**SUMMARY OF COMMUNITY DESIGN COMMISSION  
AND CITIZEN CONCEPT PLAN COMMENTS**

**Subject:** Sunrise Road Subdivision

**Meeting Dates:** August 18, 2004 and September 22, 2004

CONCEPT

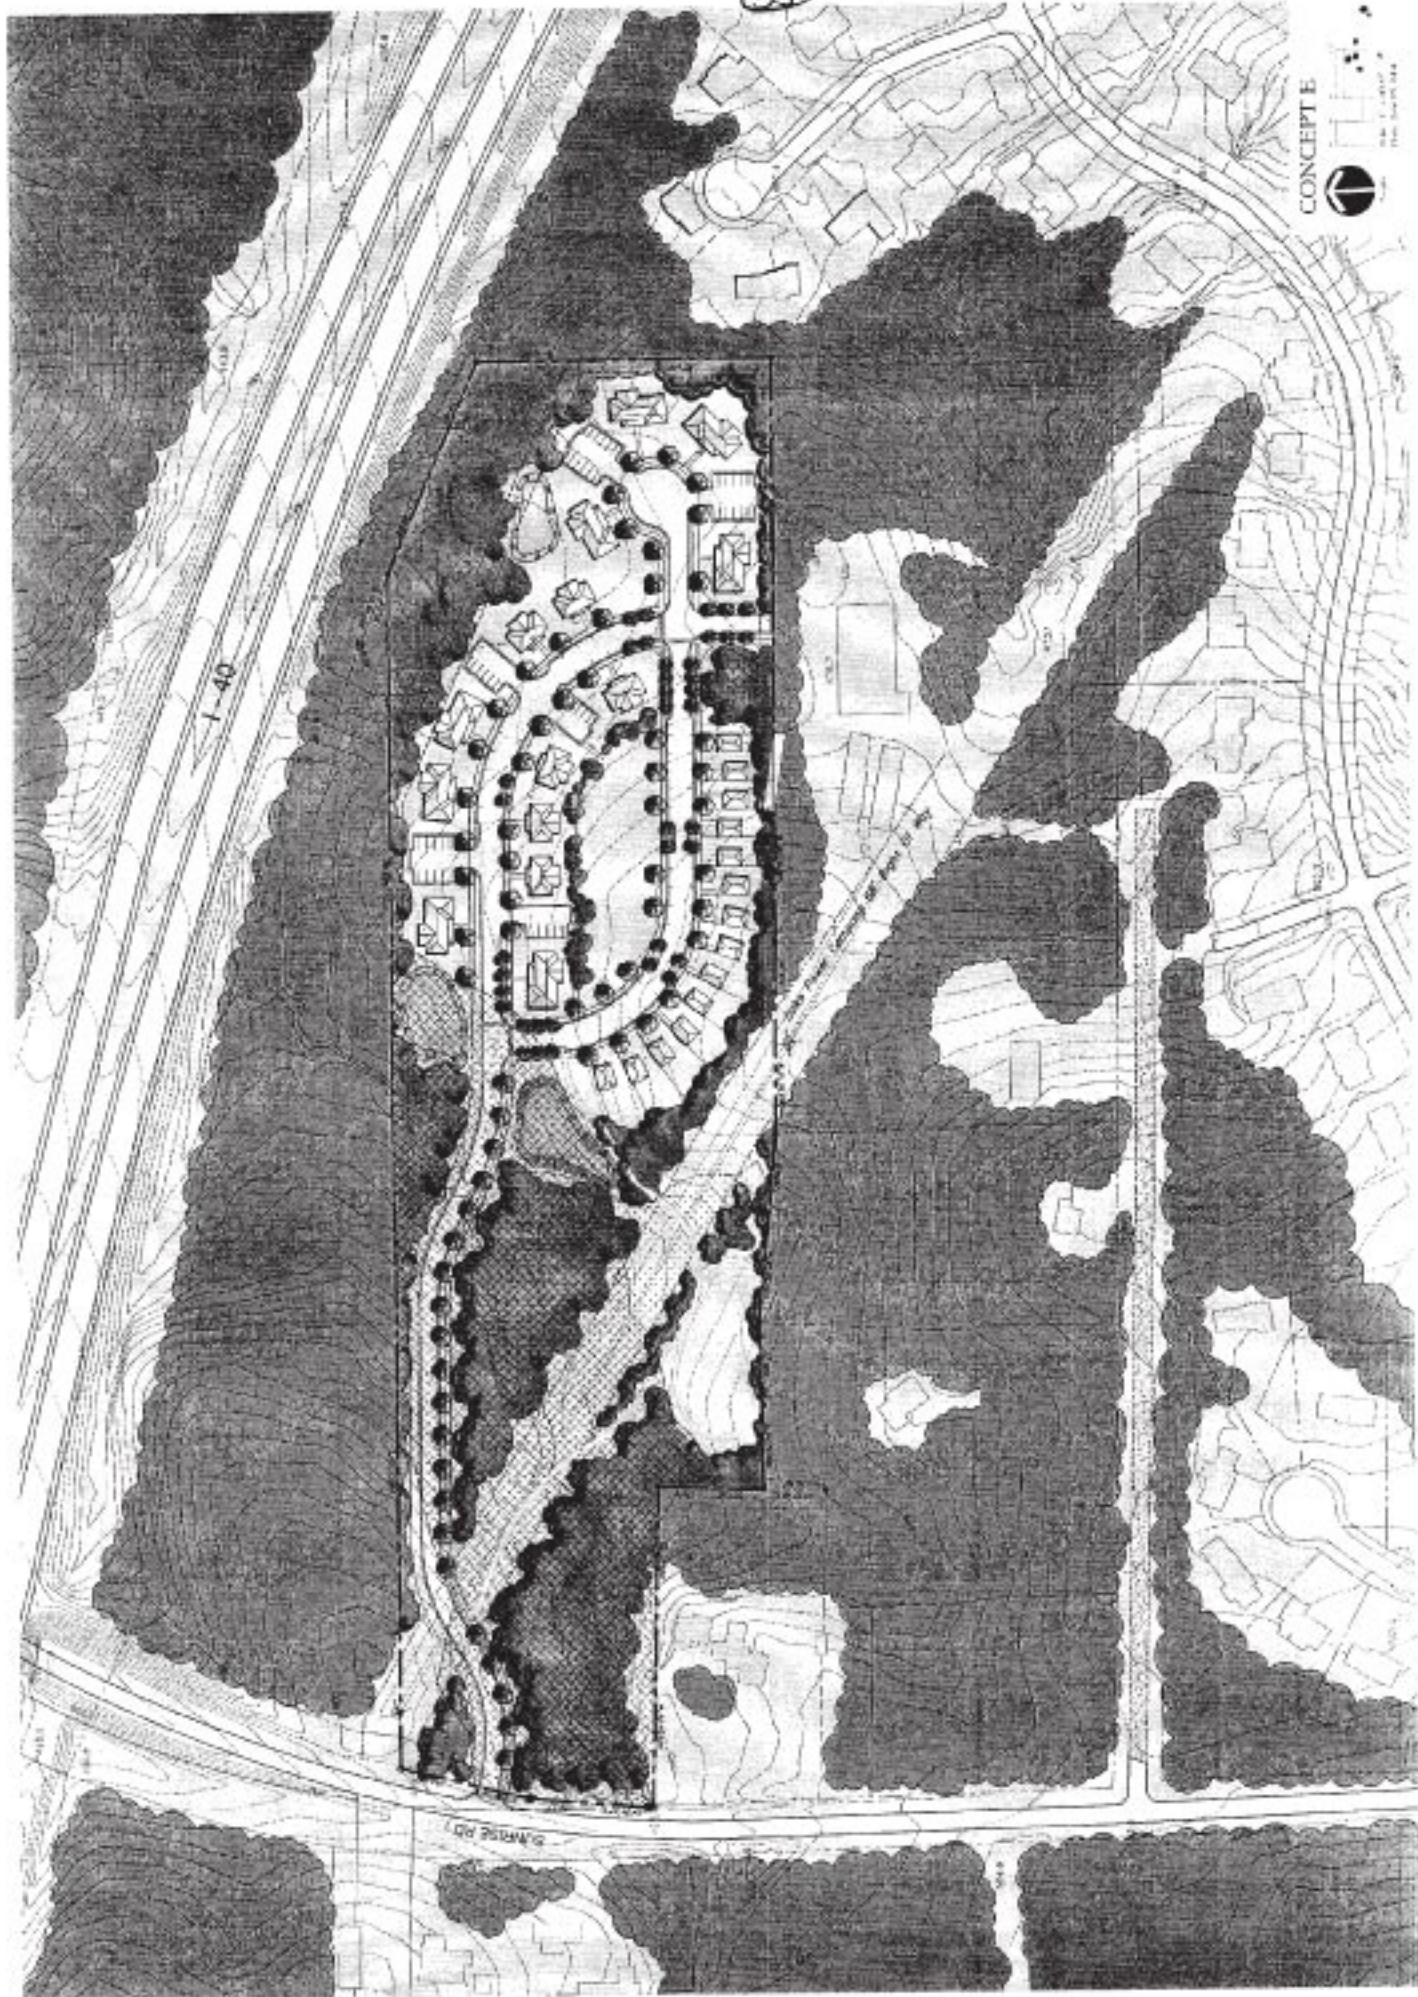
21. Several Commissioners expressed concern with children running across the southern loop street between dwelling units and the recreation area. It was suggested that the applicant consider converting the street segment to one-way east bound. It was also suggested that the applicant consider putting the roadway on the south side of the single family homes and have the homes directly front the recreation area.

22. Several Commission members also expressed concern with the applicant's proposal for on-street parking. One Commissioner stated that the proposed 2.2 parking spaces per dwelling unit is unrealistic. Commission members suggested that the applicant needs to provide well defined areas for parking and consider off-street double loaded parking and residential parking permits for on-street parking.

24. A Commissioner recommended that the proposed development included traffic calming features at two locations; at street connections between adjacent neighbors and at the west end of the proposed main street near Sunrise Road.

34. A Commissioner recommended that the applicant enlarge the proposed 15-foot wide buffer on the southeast corner to a 30-foot wide buffer.
